**Remedial Design Report, Revision 1  
Three Kids Mine  
Lakemoor Ventures LLC**

**March 4, 2024**

Re: Remedial Design Report, Revision 1  
Three Kids Mine

**Remedial Design Report, Revision 1  
Three Kids Mine  
Henderson, Nevada**

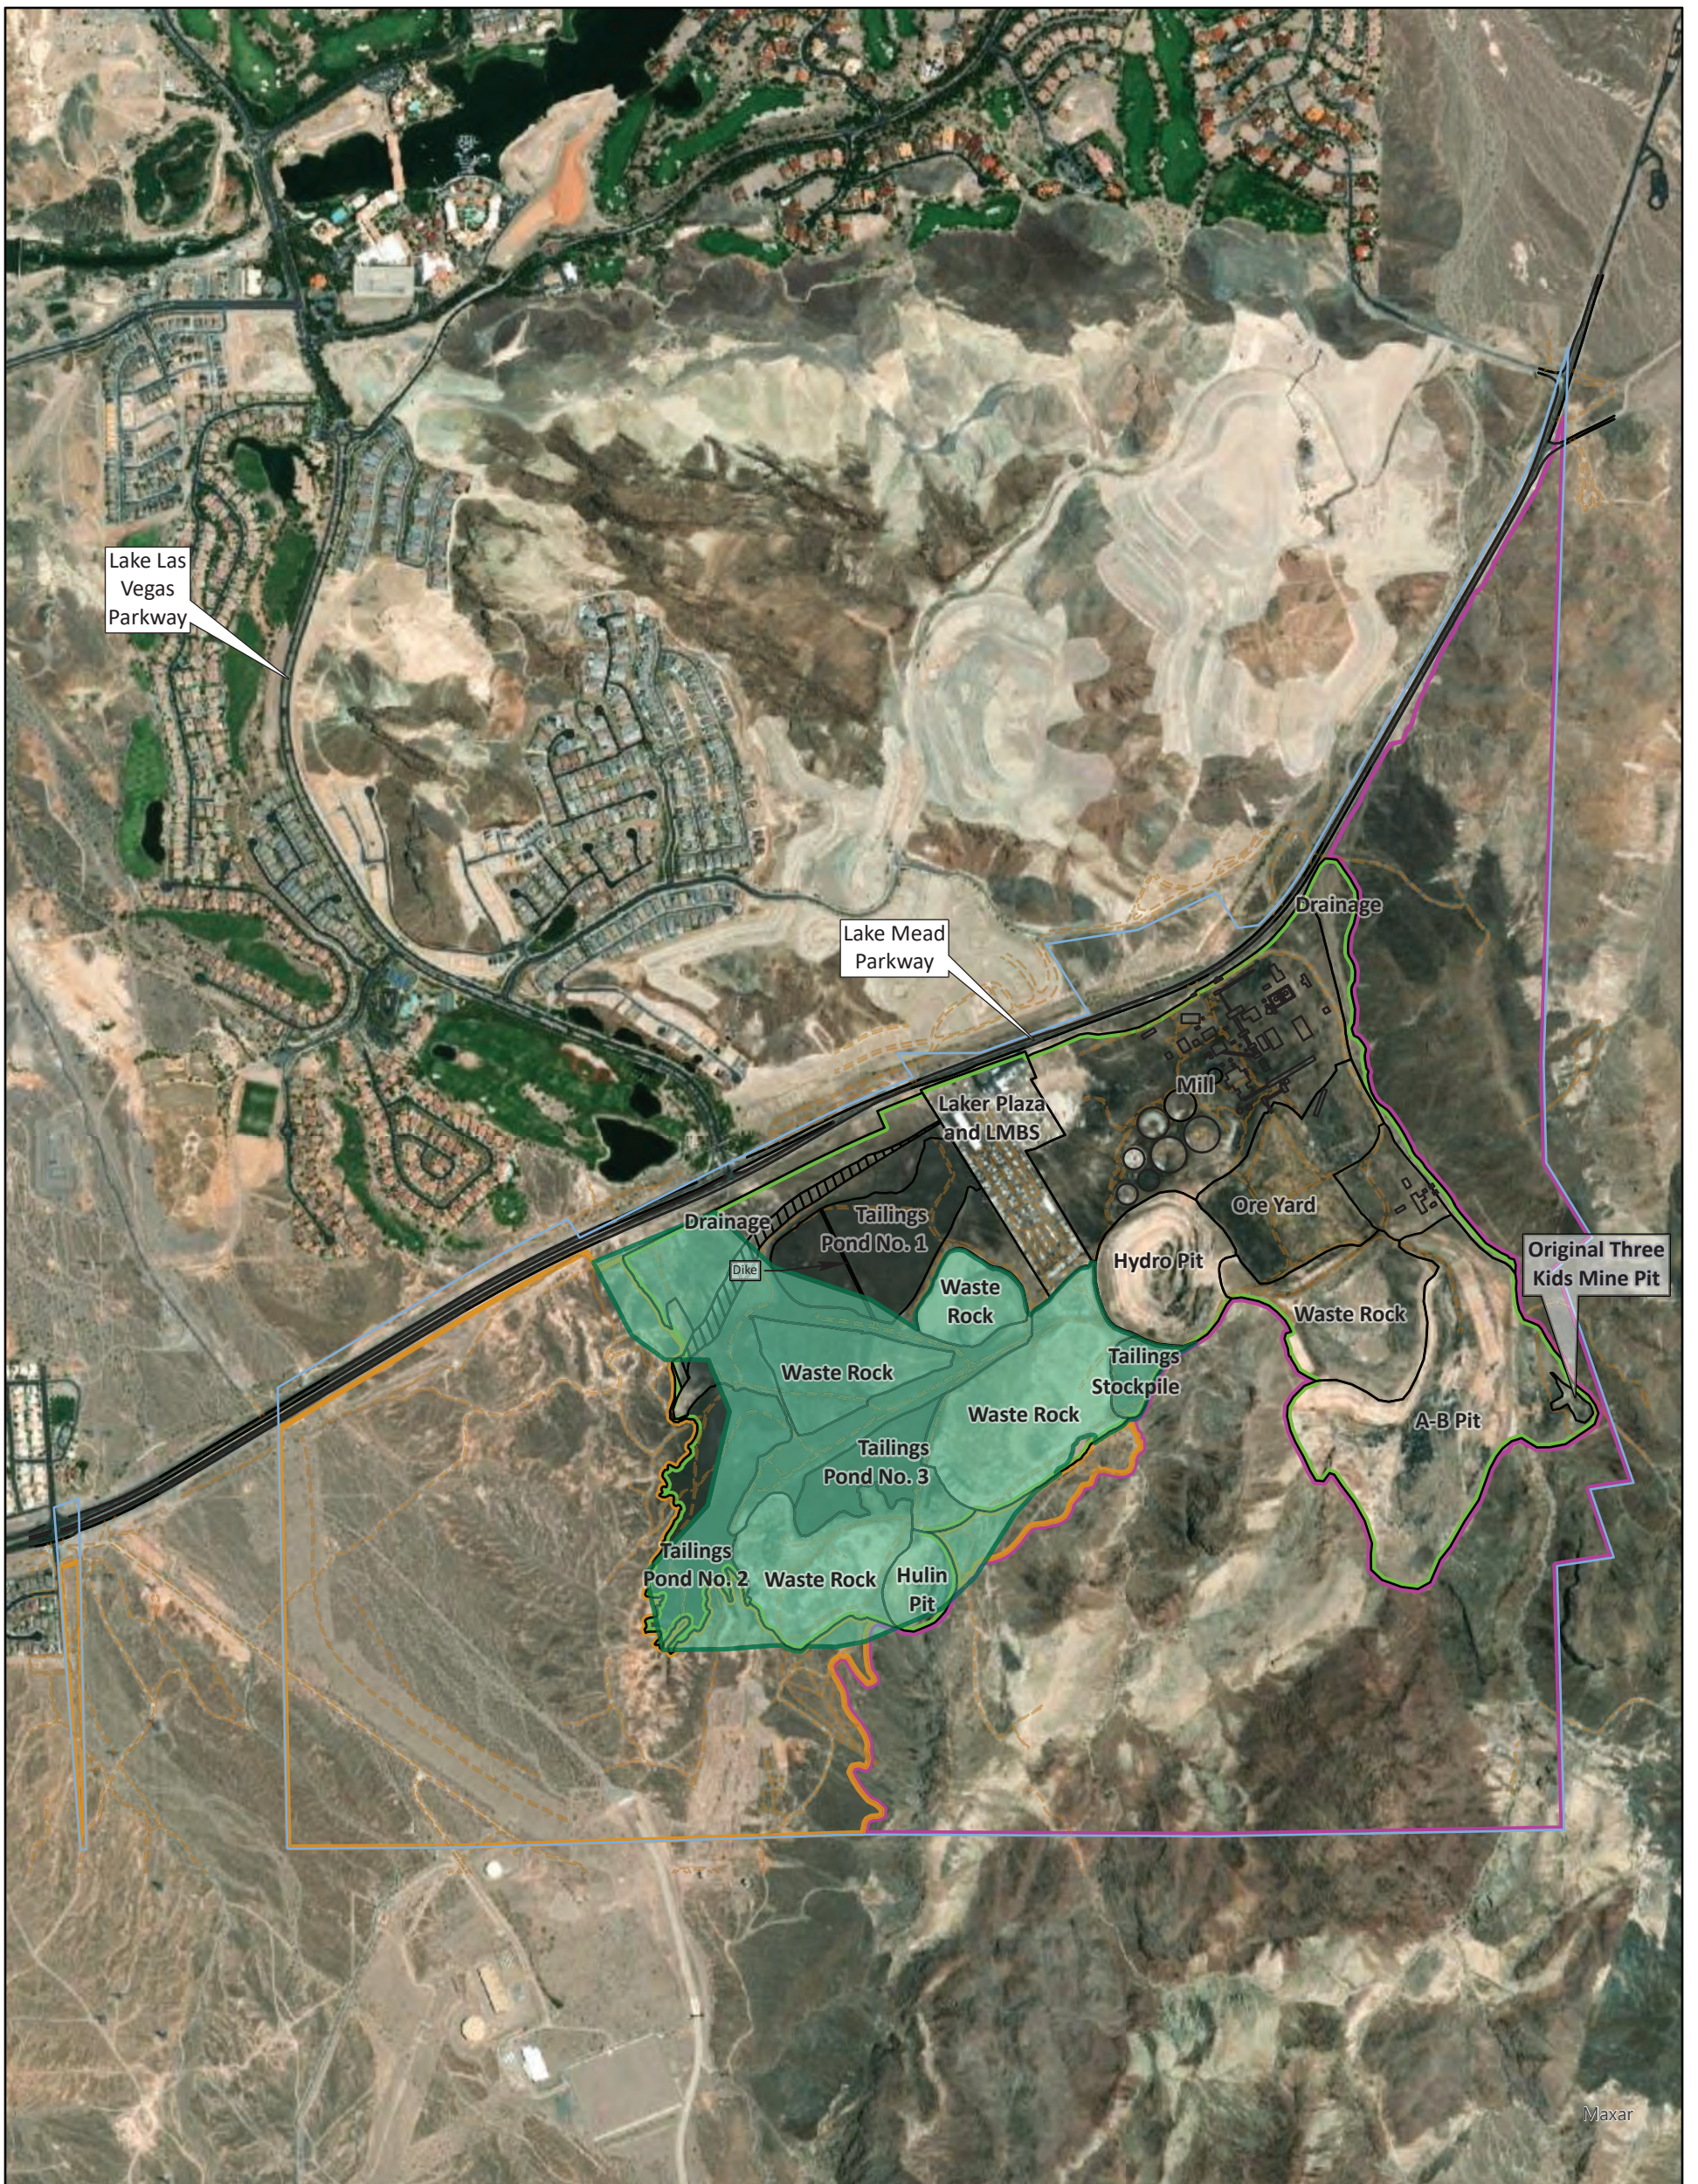
25. **Figure 4 Haul Routes** – It seems that several other haul roads will be needed to move borrow material, place material in the A-B and Hulin pits, place fill material and cover in the central valley area, etc. Please revise Figure 4 to also identify the general location of these additional major planned haul roads. Minor planned haul roads (i.e., haul roads inside the pits) do not need to be identified in the figure.

Haul road locations will be based on contractor means and methods, and the general contractor has not yet been selected. Additionally, haul roads are likely to change throughout the remediation and reclamation at the site. As a result, additional details on haul road locations cannot be provided in the revised Remedial Design Report. A note was added to Figure 4 stating that additional haul routes will be established in the future.

**Figure 8**

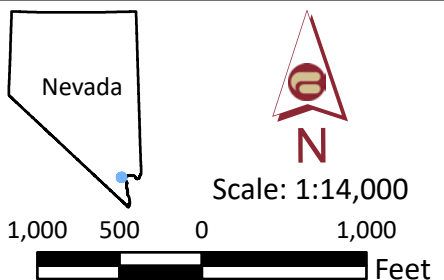
26. **Figure 7 Location of Ten-Foot Cover** – It is recommended that the word “clean” in the legend be replaced with “native soil” for consistency with the rest of the RD, including Figure G-2.

Figure 7 (Figure 8 in the revised Remedial Design Report) was updated to refer to “native soil cover” rather than “clean cover” for consistency with the Record of Decision and the rest of the Remedial Design. Figure G-2 did not require edits as it already referred to the native soil cover.
